July 16, 2019

Re: Preliminary Plat for Lavitt Manor II—Two Lot Subdivision: 7525 N. Ironwood Drive

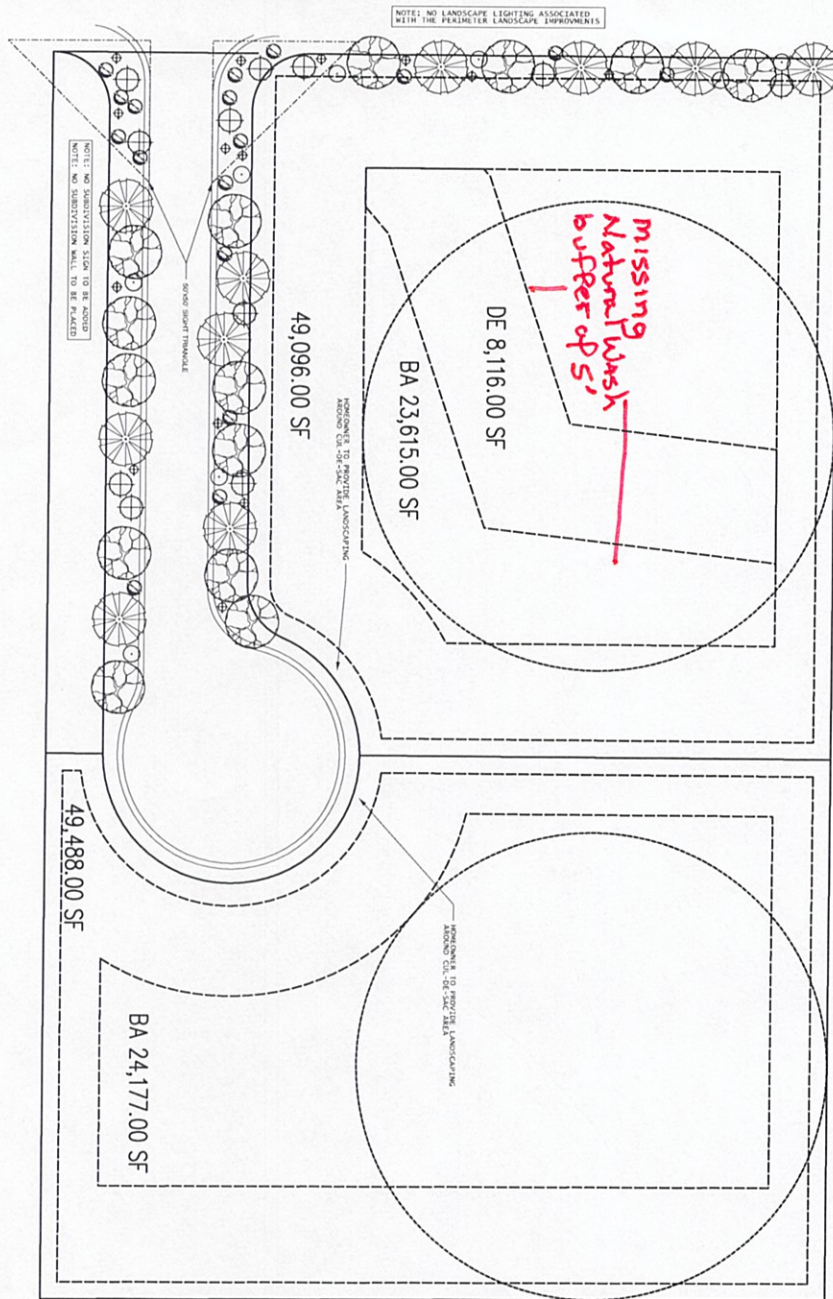
A close review of the proposed Preliminary Plat and the Paving Grading Drainage shows the five cross sections of the wash **are not** equally spaced **and not** across the entire wash (*see exhibits*); moreover, the information contained within those points selected warrant the Commission asking for further information. Point C3-6 appears in the 20 foot landscape area of the Preliminary Plat and appears to be approximately 8 feet from the beginning of the wash on the subdivision property. In contrast, point C3-10 appears to be approximately 30 feet from the end of the wash where it enters the easement created by the large Natural wash. The Storm Drainage Design Manual and the Town Code require equally spaced cross sections across the property—which the drainage cross sections provided are not. The reason for the non-equally spaced cross section points will become evident when viewed together and discussed below.

When the five cross sections provided in the Preliminary Drainage Report are analyzed it seems that Point C3-10 was merely taken in a position to ensure the smaller wash on the property was not defined as a Natural Wash or a Watercourse. First, look at the cross section points provided:

Two of the five points meet the requirements to deem the smaller wash a “Natural Wash.” However, point C3-10 is the only point that expands to the hundredth decimal position and is a mere ½ inch away from the 2.0 foot mark to make the wash a Natural Wash with an easement needing to be given to the Town to protect the wash. More importantly, look at point C3-10 on the Paving Grading Drainage Plat—point C3-10 is approximately 30 feet from where it exits into the large Natural Wash with no cross sections taken in the area (recall point C3-6 was taken only about 8 feet from the end of the wash on the south side of the property) *See exhibits*.

The reason the final cross section point C3-10 is not closer to the larger wash is because the closer the smaller wash gets to the entry to the major wash, the more the elevation drops (between 1368 and 1366 feet) and the wider the wash gets. Necessarily, if the cross section points

were taken equally spaced across the entire smaller drainage wash as required by the Town Code and Storm Drainage Design Manual (or an additional point is taken between point C3-10 and the exit of the smaller wash into the major wash), there would assuredly be at least three points that exceed a depth of 2.0 feet and width of 5.0 feet—making the smaller wash a Natural Wash or Watercourse. At a minimum, the Commission needs to investigate this issue given the Code requirement of equally spaced cross sections **across the property** was not followed completely and there appears to be an attempt to influence the Commission to believe the smaller wash is not a Natural Wash or Watercourse.

Does not show required Landscape Buffer here or on plat 3-6(3) Storm Drainage Design Manual
